# SALINAS-AG INDUSTRIAL CENTER

SCH #2008041171

Final Program EIR

# RESPONSE TO COMMENTS

Chart 1: Discharge to Reclamation Ditch

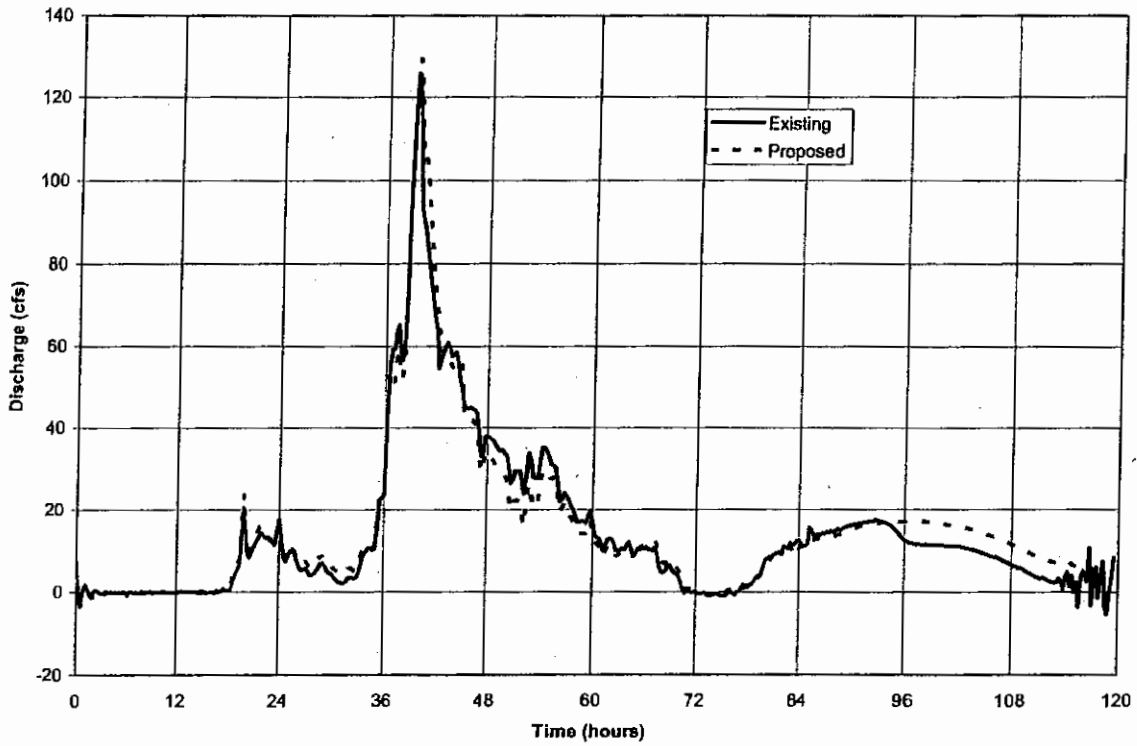
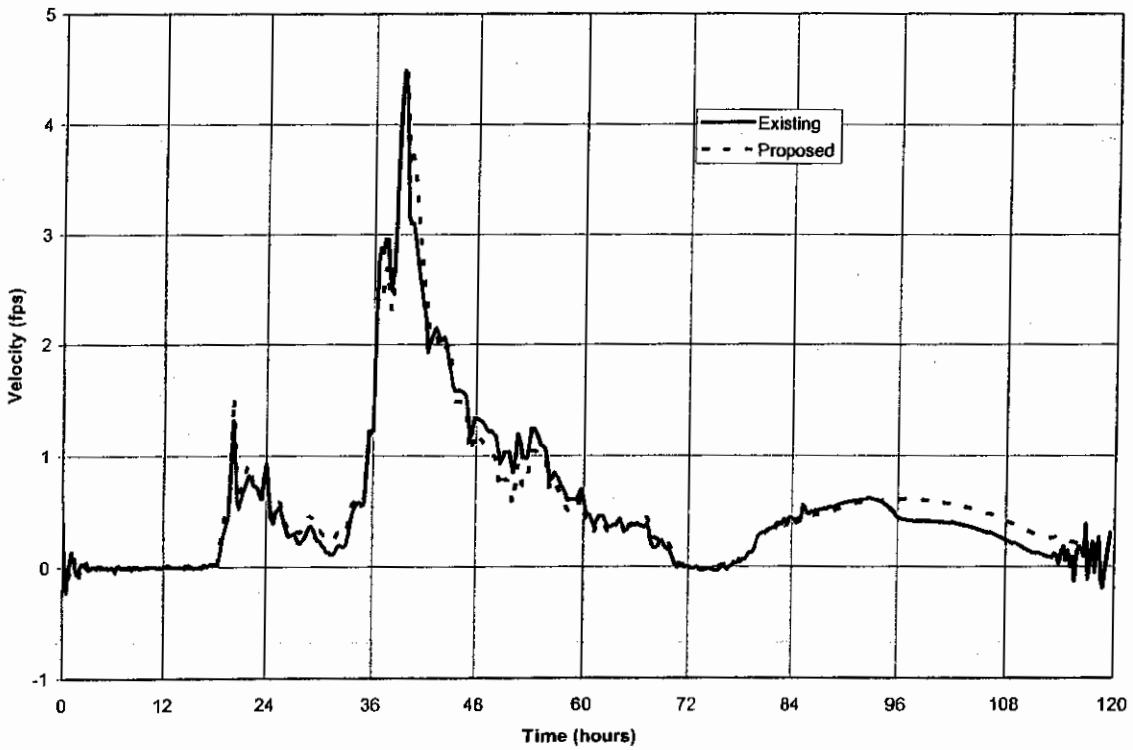
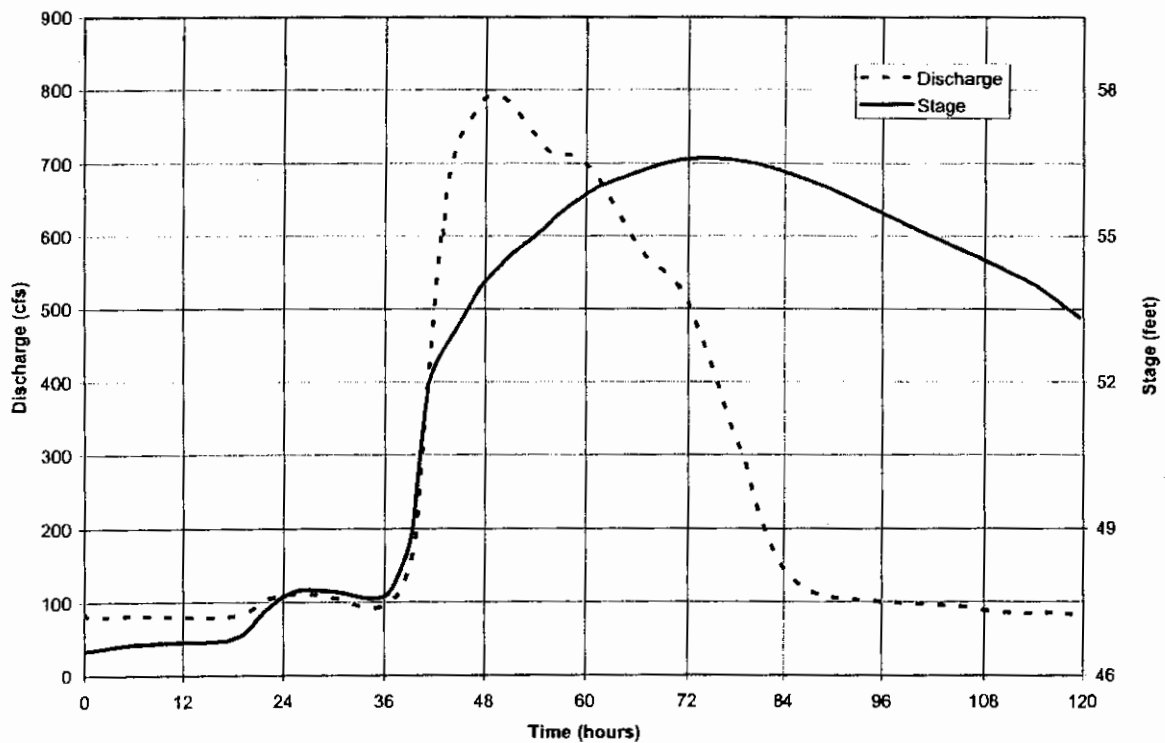
**Outfall Structures** – The project proposes to route runoff from the site to existing storm drain lines that are connected to existing outfalls that discharge to the Monterey County Water Resource Agency (MCWRA) Reclamation Ditch. The project has proposed no modifications to the existing outfall structures or to the Reclamation Ditch near the outfall locations to account for the proposed higher volumes, rates, and longer durations of runoff discharging at these outfalls. The project proposes to increase peak runoff rates by 61 percent over the existing condition and this hydromodification of the site will increase the peak discharge at these outfall points by 3 percent. The DEIR does not adequately assess the impact this increased discharge rate will have on the Reclamation Ditch at the existing outfalls. The final EIR must include more evidence to justify the existing outfall structures can withstand additional flows without causing significant erosive effects to the Reclamation Ditch near the outfall locations, or identify measures to mitigate this potentially significant impact.

2. The statement that the proposed project proposes to increase peak runoff rates by 61 percent over the existing condition does not accurately describe the potential impact of the proposed project. The potential impact of the proposed project on runoff rate, volumes and durations may be better understood by viewing these graphically. Charts 1 and 2 illustrate discharge rates and velocities in the 72-inch outfall pipe to the Reclamation Ditch during a 100-year storm event. These graphs show that proposed discharges are higher at some points and lower at other points during the design storm.

The potential for increased discharges to cause significant erosive effects to the Reclamation Ditch depends on the duration of high velocity discharges. In that discharge velocities never exceed five feet per second (fps) during the 100-year event, and only exceed 4 fps for a short period during the 100-year event, high velocity discharges are not a significant factor. Based on the durations that velocities are above two fps during a 100-year event, it can readily be concluded that even potential mildly erosive discharge velocities are rare, short duration occurrences that would not measurably contribute to sediment loading. Therefore, no additional mitigation other than the onsite detention being proposed should be necessary to mitigate for this potentially significant impact.

To understand the potential significance of hydromodification of this site, it should be understood that delaying runoff from the site [even if there is no increase in the volume of runoff as is typically the case with the implementation of low impact design (LID) measures] is not necessarily beneficial to the regional drainage system because delayed releases can actually cause local peaks to more closely coincide with the timing of system-wide peak flows. Chart 3 illustrates discharge and stage hydrographs in the Reclamation Ditch near the 72-inch outfall.

At the time of peak discharge in the 100-year event in the Reclamation Ditch (hour 50), the proposed condition discharge from the 72-inch outfall is lower than the existing condition. At the time of peak stage in the Reclamation Ditch in the 100-year event (hour 74) there is no discharge from the 72-inch outfall because backwater blocks outflow.

To mitigate for the added impervious area on the site, a system with multiple detention facilities with outflow regulated by orifices and weirs is proposed. The detention basins would permit percolation of runoff, but the system analysis was performed assuming that there would be no infiltration. The inconsistent layers of silt, clays, and dense sands preclude the ability to establish sustainable percolation rates for design, though some amount of percolation will occur. The proposed site includes over 55 acre-feet of detention storage capacity. This is much more than the existing site which has about 18 acre-feet of effective detention based on existing topography and 24-inch outlet. The proposed 55 acre-feet corresponds to approximately 0.24 acre-feet of detention capacity for each proposed impervious acre and that the site proposes to add. This is about 37 acre-feet of detention storage, or 0.16 acre-feet per impervious acre over the existing condition. Detention storage of about 0.16 acre-feet per impervious acre is typical for hydromodification management measures designed to meet Santa Clara Valley or Contra Costa County requirements. The proposed detention system was developed to limit impacts on the receiving waters. Therefore, it would be reasonable to assume that the proposed project includes sufficient detention capacity to mitigate for hydromodification impacts to the maximum extent practicable.
